March 9, 2010

Subject: **Legistar #15932 Adopting and confirmed amendments to the MGOs to revise the City's Zoning Ordinance—*Long Range Transportation Planning Committee Recommendations***

Summary of suggested Bicycle-Related changes to draft ZO as reviewed by LRTPC,
1-21-10

Rack design

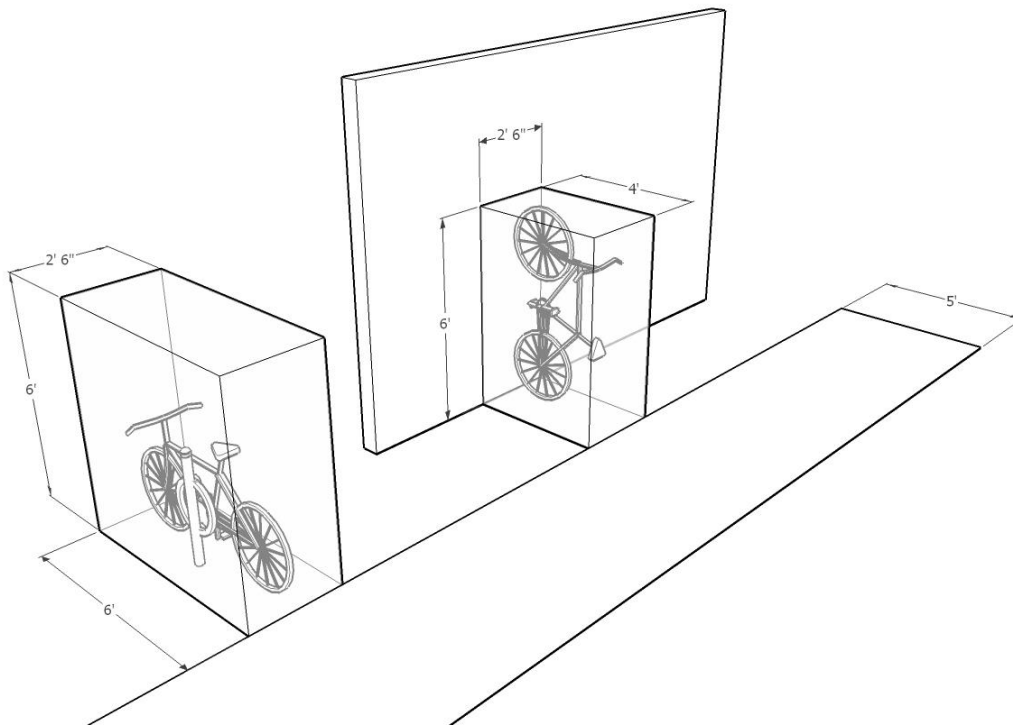
Ground mount (non-vertical) rack & spacing

- Support a wheel and frame in the center of the bicycle parking stall (no overlap), keeps wheel and frame in a single plane and prevents rotation of the bicycle when placed in the rack,

- Separate rack designs to apply to short term and long term parking,
- Who approved the rack?
 - Ordinance defines rack, Zoning Administrator approves, with consideration/guidance from TE. (allows for creativity).

- Approval of racks should include # of bike parking spaces the specific rack is designed to accommodate from manufacturer.
- Need 6' vertical clearance requirement,

- Does 3% slope work to provide stable surface for rack mounting?
- Surfacing: must be paved with materials approved by asphaltic or concrete surface approved by DPW, and may use pervious paving (no gravel, landscape stone, woodchips,)

- Provide examples of acceptable racks in supporting document,
- Accommodate U-lock (including removal of front wheel and locking it to the rear fork and frame) and cable lock,

- Eliminate 2.5' width if information from rack manufacturers reflects rack side is not modular standard or being manufactured (keep current 2' width).
